# ADDENDUM #5

Reference: Losee Center Remodel  
Utah Valley University – Orem, Utah  
DFCM Project No. 07196790

Project: UVU Losee Center Remodel  
DFCM Project Number: 07196790  
Axis Project Number: 0719  
Date: August 28, 2008

**ENTRY PAVING AND EXTERIOR**

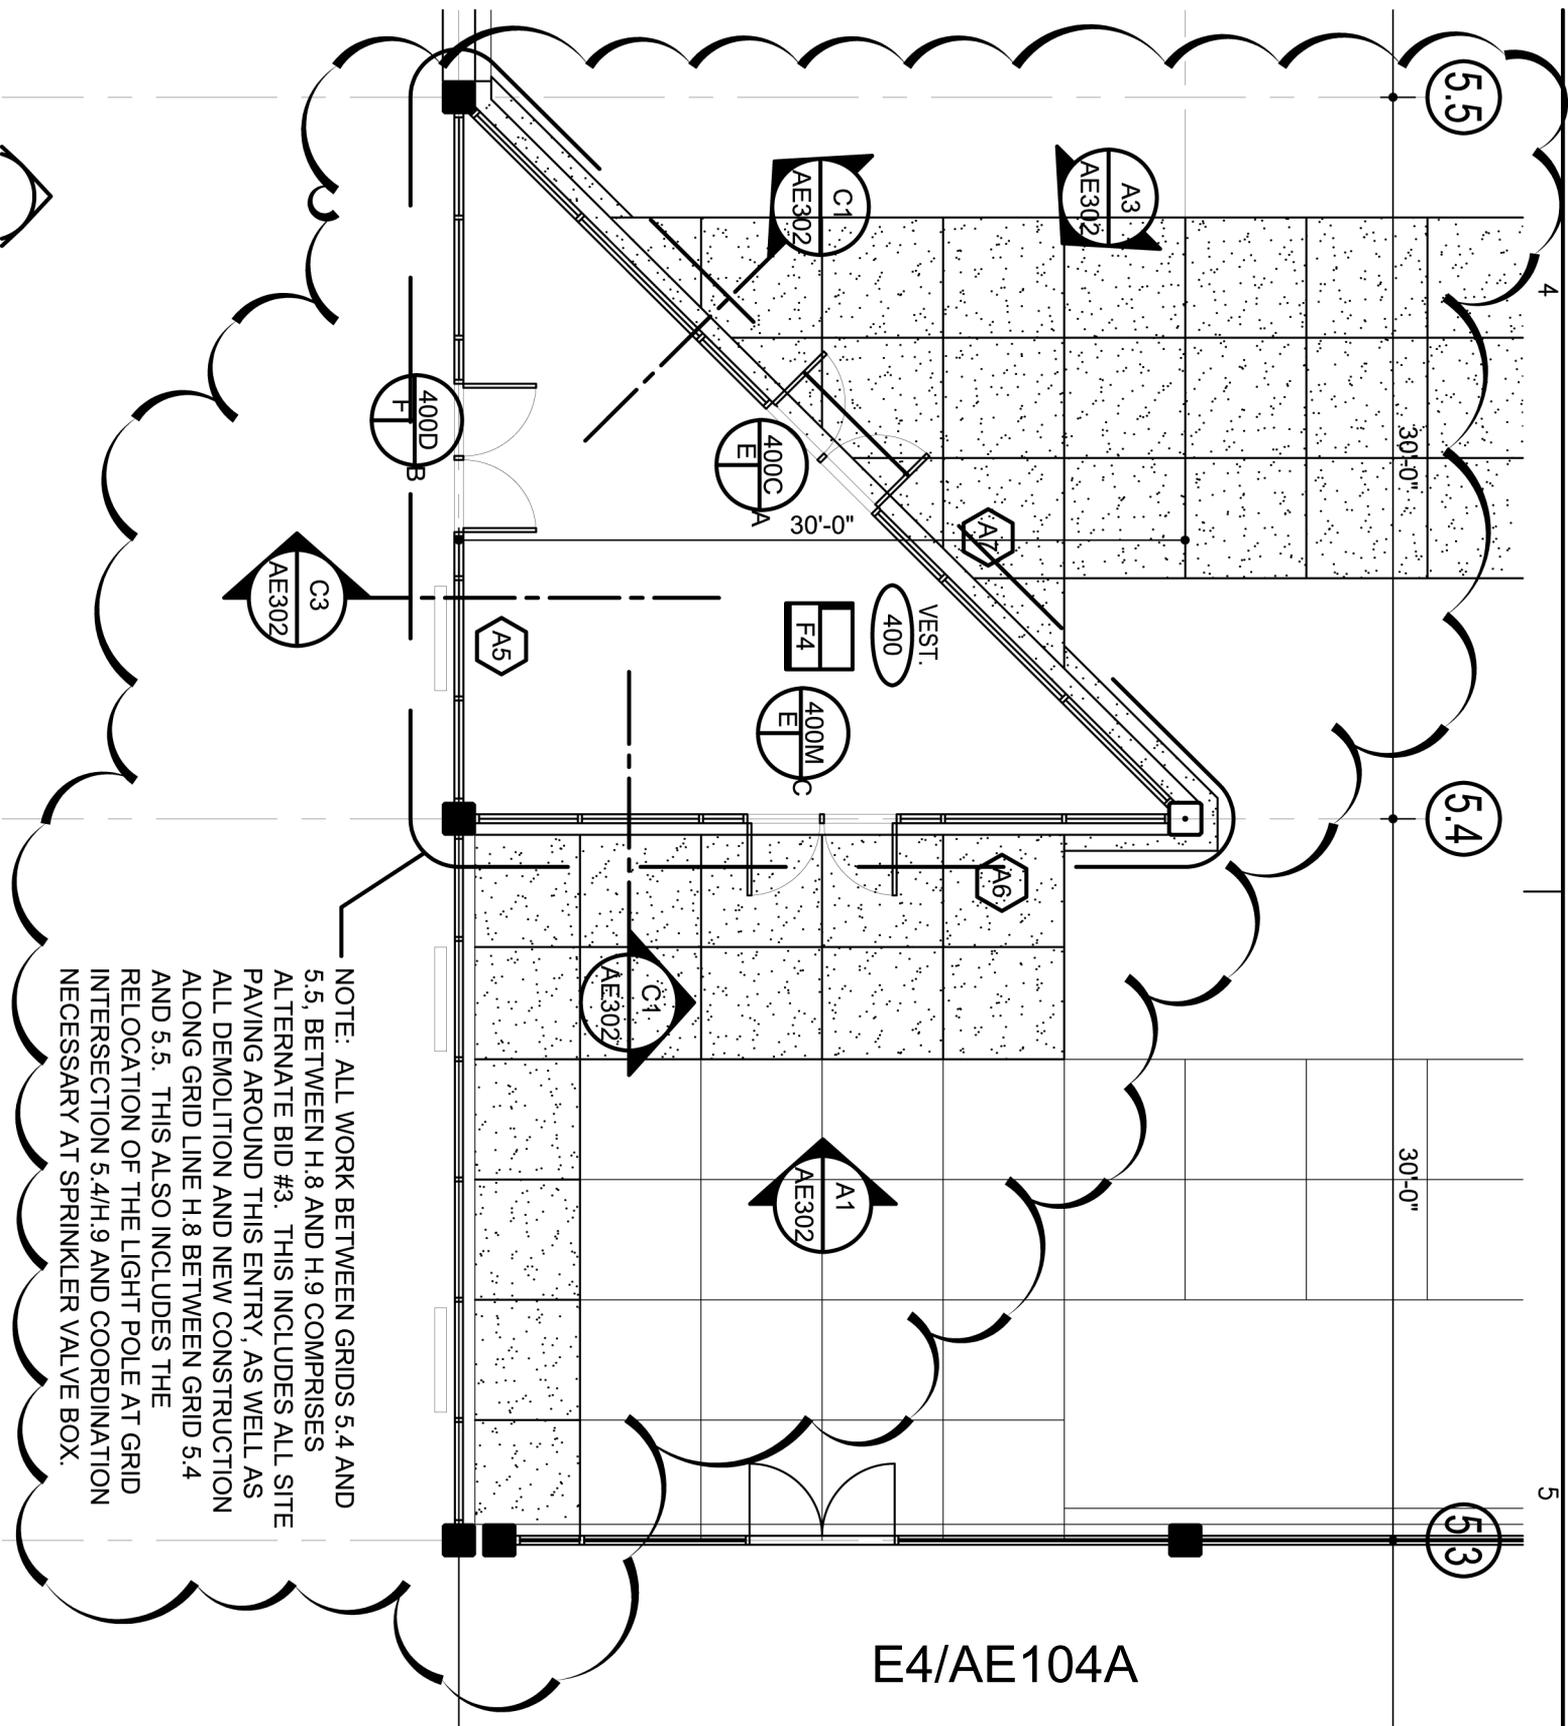
**5.11** Sheet AE104A: Add attached drawing A1/AE104A and E4/AE104A.

NOTE: ALL WORK BETWEEN GRIDS 5.4 AND 5.5, BETWEEN H.8 AND H.9 COMPRISES ALTERNATE BID #3. THIS INCLUDES ALL SITE PAVING AROUND THIS ENTRY, AS WELL AS ALL DEMOLITION AND NEW CONSTRUCTION ALONG GRID LINE H.8 BETWEEN GRID 5.4 AND 5.5. THIS ALSO INCLUDES THE RELOCATION OF THE LIGHT POLE AT GRID INTERSECTION 5.4/H.9 AND COORDINATION NECESSARY AT SPRINKLER VALVE BOX.

NOTE: ALL WORK BETWEEN GRIDS 5.4 AND 5.5, BETWEEN H.8 AND H.9 COMPRISES ALTERNATE BID #3. THIS INCLUDES ALL SITE PAVING AROUND THIS ENTRY, AS WELL AS ALL DEMOLITION AND NEW CONSTRUCTION ALONG GRID LINE H.8 BETWEEN GRID 5.4 AND 5.5. THIS ALSO INCLUDES THE RELOCATION OF THE LIGHT POLE AT GRID INTERSECTION 5.4/H.9 AND COORDINATION NECESSARY AT SPRINKLER VALVE BOX.
